Wheeler River Joint IR Technical Meetings – FIRT and Denison June 2024 (Round 3 Submission)

Meeting #1: Wheeler River IR Meetings (IR-100, IR-190 and IR-198-R1)

IR #	Summary of Discussion	Action / Next Steps
IR-100	<p>Denison clarified to HC that in the Round 2 response to IR-190-R1, Denison did not propose to use Government of Saskatchewan fish consumption guidelines.</p> <p>In response to this IR, Denison will clarify the information/commitments/plan already provided on IR-212 (country food monitoring framework) and edit commitment 8-44 to reflect adaptive management on how country food monitoring data influences ERA updates (which are regularly done through the licence requirements per CNSC oversight and N288.6).</p>	<p>Denison’s response will outline the commitment in the EIS to the overall development of trigger levels through the country food monitoring program. They do not plan to calculate the trigger levels for the purpose of the IR but would describe how it would be calculated and used. Same generic adaptive management cycle for all aspects of monitoring and follow up cycle.</p> <p>Denison to provide clarification through an interim IR response for SME Review. For revie

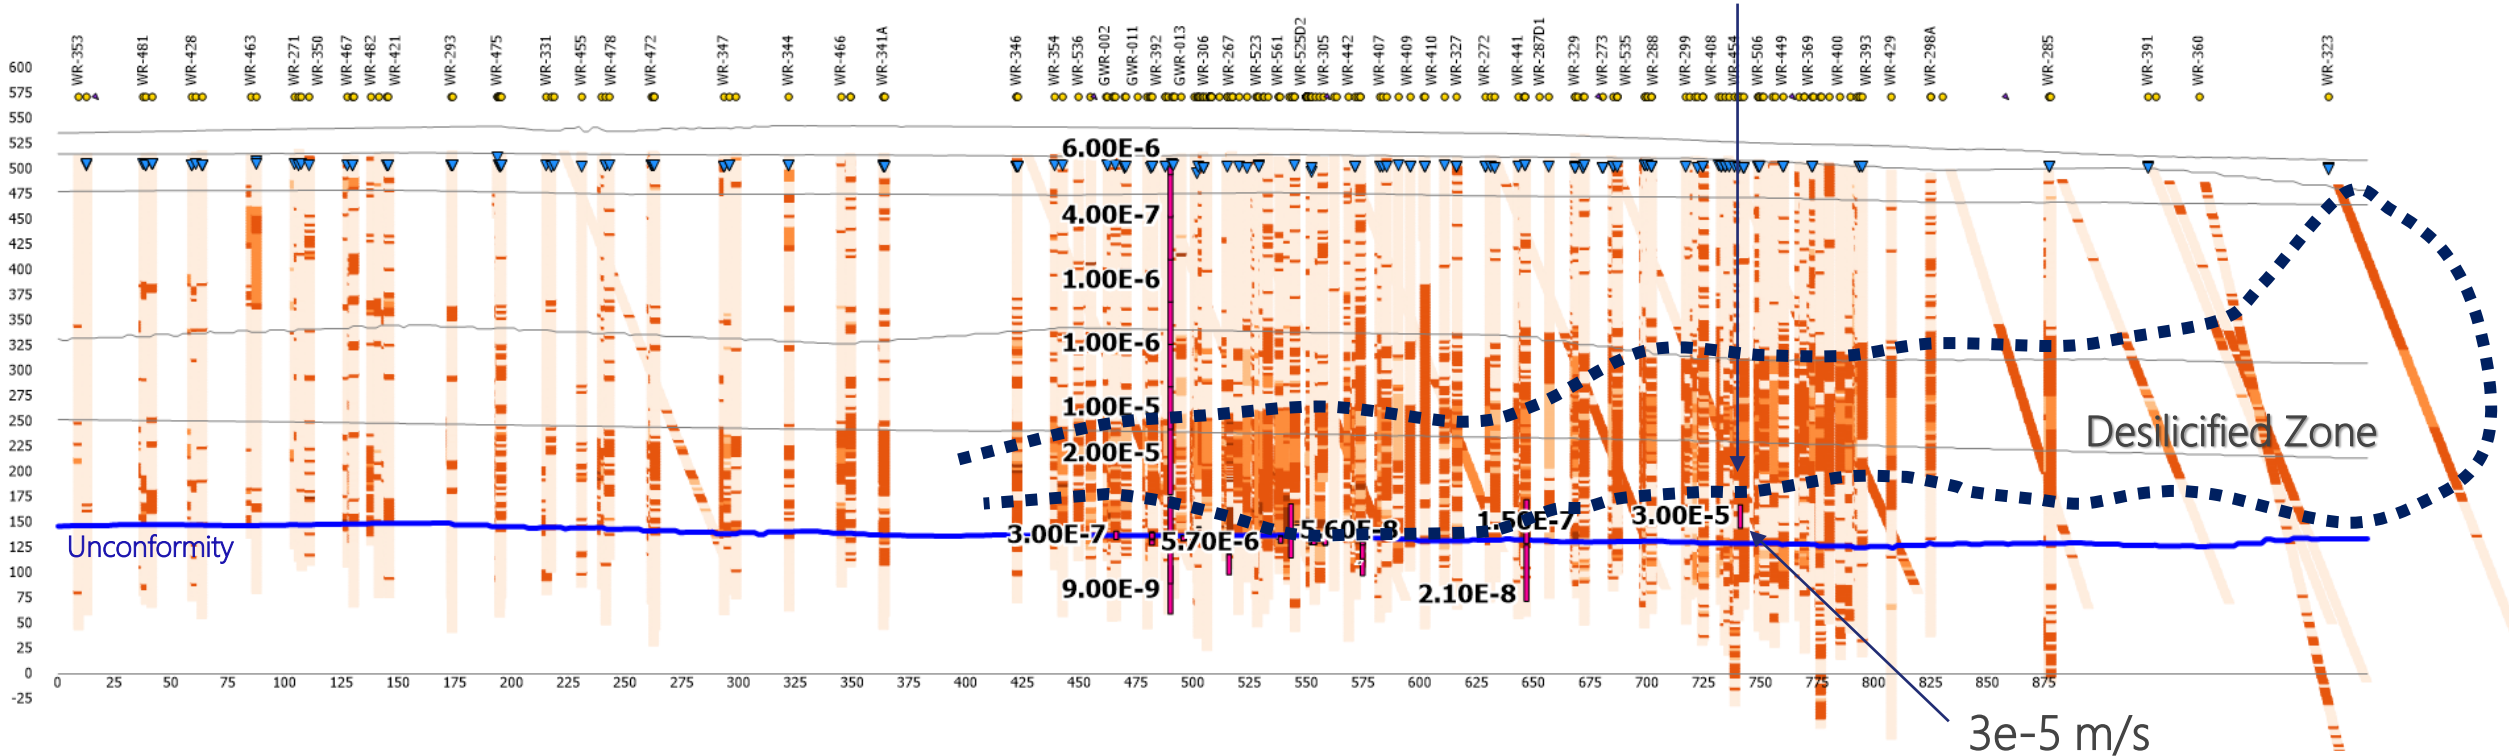
- Round 3 – Context, Rationale and IR (May 2024)
 - Test a K value in the DSZ with a value at least an order of magnitude higher than the highest field K values
 - Clarify why the geomean K value for the DSZ was modified and provide any supporting evidence.

Packer interval at WR-405 was attributed to Lower Sandstone Aquifer as there is lower friability within the packer interval than is present in the DSZ

Figure 3-2 in Appendix 10-A

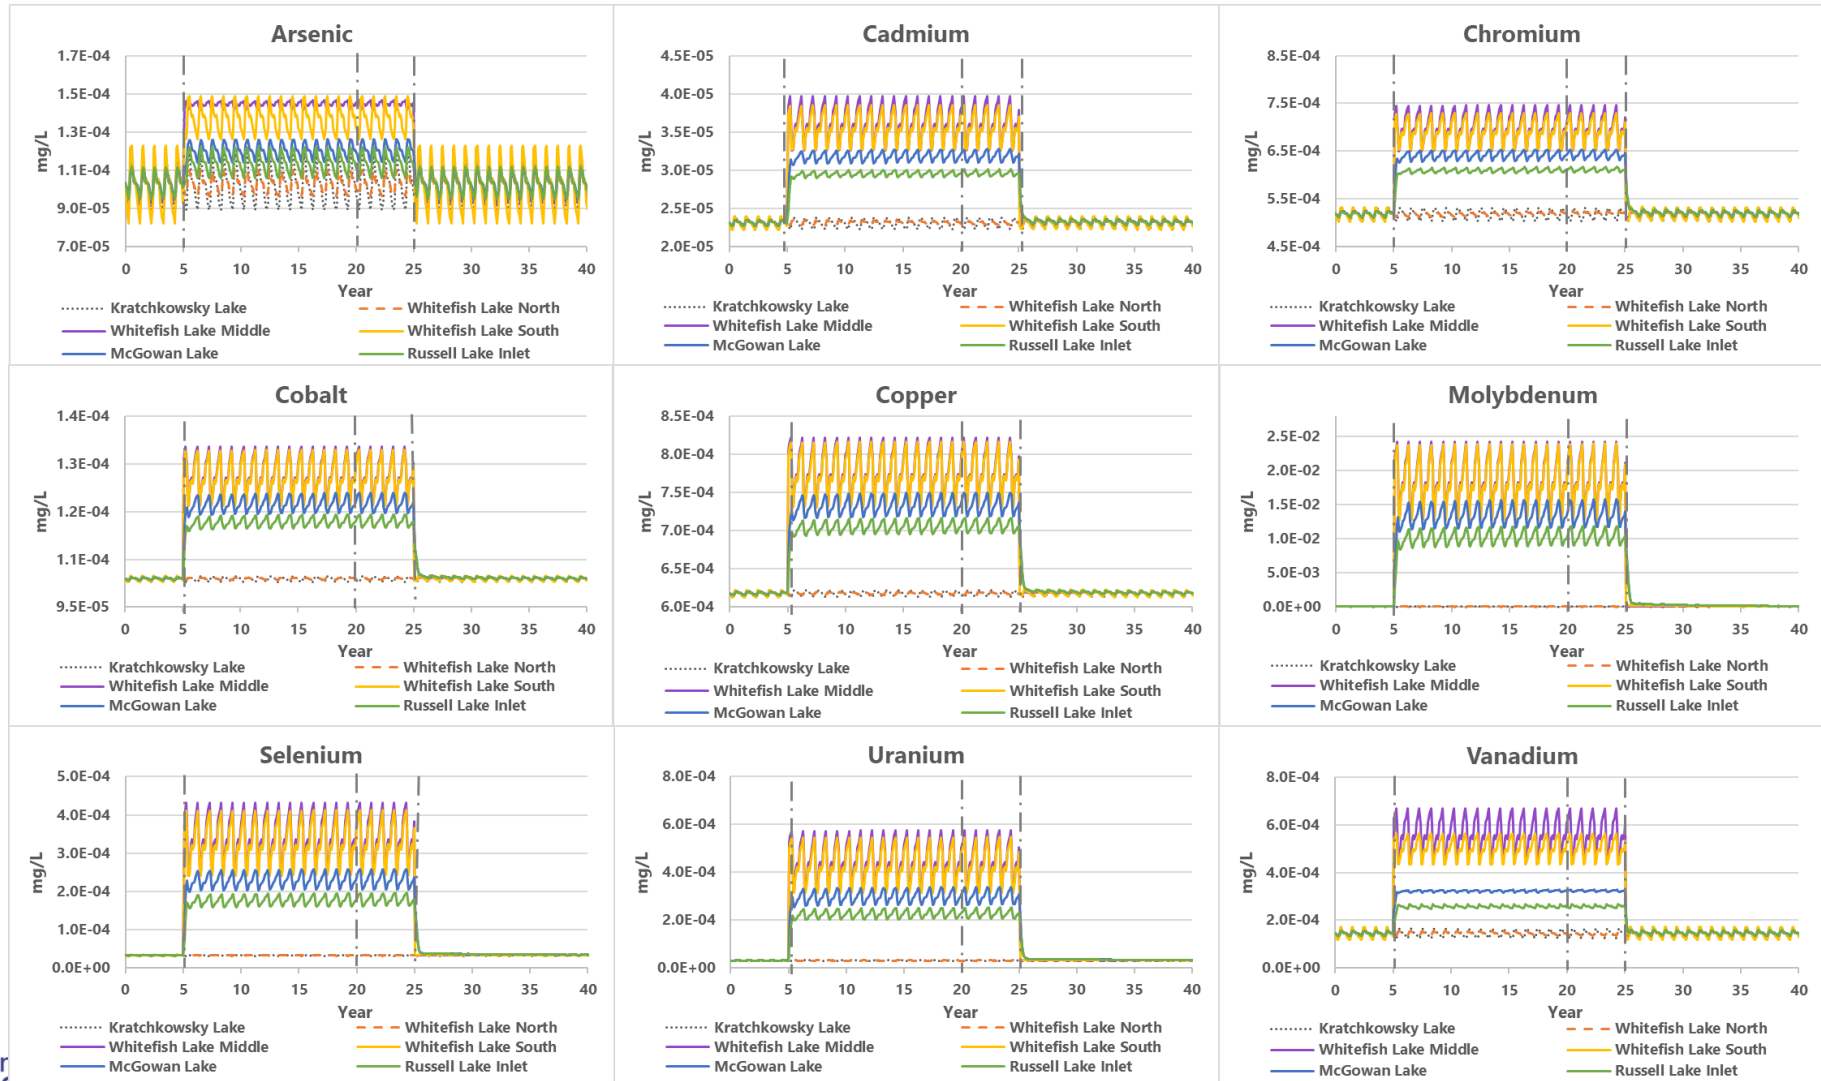
IR-124-R1 (ROUND 3, May 31, 2024)	Discussion
<p>The Proponent has not fully responded to the previous round's IR. The modeling of surface water and sediment COPC's described in Appendix 10-A, Figure 6-1 and 6-2 respectively shows results for the receiving waterbodies. However, it is unclear if these modeled values are based on the worst-case scenarios that account for environmental variables such as seasonal changes in hydrology and chemistry, or if they have only accounted for changes in operational effluent discharge scenarios to consider the upper bound discharge rates. The Proponent's responses regarding baseline exceedances of COPC thresholds in the receiving waterbodies require additional information regarding environmental variability, including but not limited to seasonal changes in water levels, flows and sedimentation, in order to determine whether the model has considered environmental variability. The Proponent should also demonstrate that the model has fully considered a reasonably expected worst case scenario, such as a 100-year return period for the above variables.</p> <p>The Proponent should include a consideration of the maximum COPC scenario for the receiving water bodies in baseline assessments and the risk assessment, including seasonal variability and sediment depositional areas, to consider the effects of the operations of the proposed mine.</p>	<p>To clarify, the environmental risk assessment considers both seasonal variability including changes in monthly flows as well as consideration of sediment deposition in the whole lake.</p>

The sediment model represents deposition in the whole lake using partition equations. There is not a significant release of particulates; therefore, the dominant process is expected to be partitioning not particle settling – TSS in effluent is low (6 mg/L).

Selenium in White Sucker over Time (LA-5)

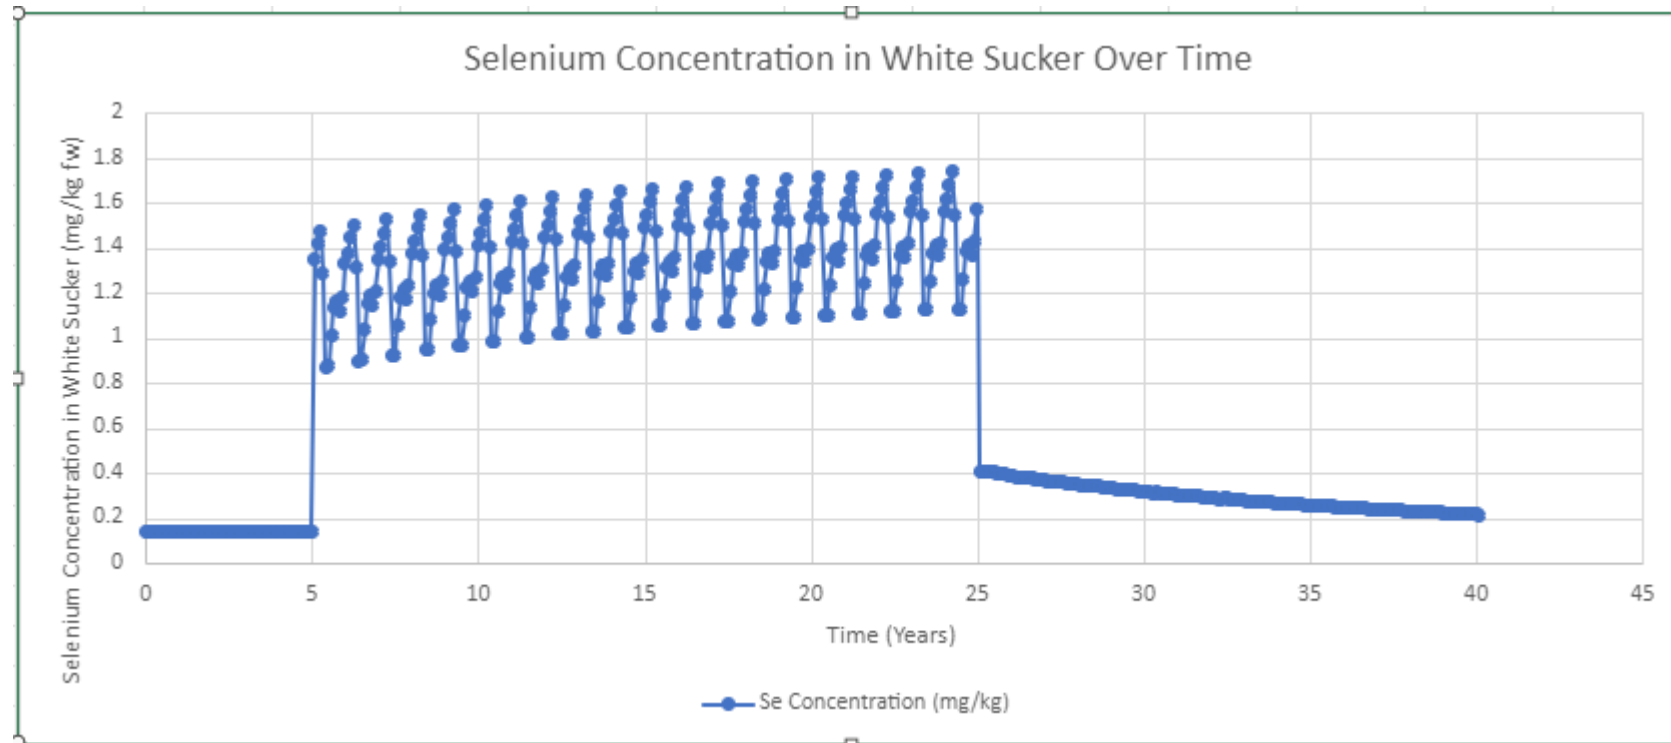
IR-126 (ROUND 3, May 31, 2024)	Discussion
<p>The Proponent did not compare their predictions for fish tissue selenium to the FEQGs in the ERA as requested. Furthermore, in their response the Proponent does not use available species-specific moisture content and conversion factors available for northern pike and lake whitefish when converting muscle selenium concentrations to whole-body selenium concentrations. This means that the Proponent's prediction likely underestimates the selenium tissue concentrations in the fish. Consequently, the hazard quotients reported are lower than expected. Additionally, the method used by the Proponent to predict selenium concentrations in northern pike and lake whitefish does not appear to include dietary uptake and bioaccumulation of selenium, only direct contact with pore water and overlying water is considered (Table 5-5 in Appendix 10A; Section 2.2.2 of Appendix A to Appendix 10-A). Selenium uptake through the aquatic food web has been shown to result in bioaccumulation of selenium in aquatic-dependent wildlife and resulting in reproductive impairments and malformations (ECCC 2022). Dietary sources of selenium would typically be expected to be the main contribution to tissue concentrations of selenium compared to selenium uptake from water. In most situations, the conversion of inorganic selenium to organic selenium through uptake from water into periphyton/algae is the rate limiting step of selenium bioaccumulation into higher level organisms including benthic invertebrates and fish. This step is affected by many environmental parameters (e.g. temperature, substrate, lentic/lotic environment). Considering that the effluent discharge contains 42 ug/L selenium, consideration of dietary selenium is warranted.</p> <p>The Proponent should update the final EIS with the following information:</p> <ol style="list-style-type: none">1. Update the ERA with the assessment of selenium concentrations in fish tissue to include a comparison of selenium fish tissue concentrations to ECCC FEQG guidelines for either fish whole body tissue (6.7 ug/g dry weight) or fish egg/ovary tissue (14.7 ug/g dry weight) <u>using</u> species-specific moisture content and muscle : whole body and/or egg-ovary : muscle conversion factors (see Tables B-1b, Table B-3, Table B-4, and Table B-5 in US EPA (2021)).2. Update the ERA for the assessment of selenium concentrations in fish tissue using a method that considers dietary uptake and bioaccumulation in order to determine predicted fish tissue concentrations of selenium in northern pike and lake whitefish. This is recommended to be done over all Project phases for both the Expected Case and sensitivity scenarios.3. Provide predicted fish tissue selenium concentrations that include the range of variability of data used to develop the tissue selenium predictions. Only one output value without a confidence interval is provided for each location and species (see Table B.5 in Appendix B of Appendix 10-A).	<ol style="list-style-type: none">1. Round 2 IR response provided a comparison against the ECCC FEQG by converting the muscle tissue concentrations to whole-body tissue concentrations using generic conversion values. The dry weight to fresh weight conversion factor used was 0.25. Based on measured dry weight content in fish (northern pike and white sucker the dry weight content ranged from 0.24 to 0.26 which is consistent with literature values; therefore, there is no need to change. (see next slide for additional results).2. The ERA has done what the reviewer is requesting. The ERA utilizes a bioaccumulation factor (BAF) model from water to tissue to conservatively reflect all the multi-media contributions to update. The BAFs are provided in Appendix A to the ERA in Section 3.6.1.3. The fish tissue selenium concentrations represent the maximum concentration over the Project phases. This is the most conservative result.

Conclusion: There is minimal difference between previous assumptions and updated assumptions. All results still below the ECCC FEQG of 6.7 µg/g dry weight
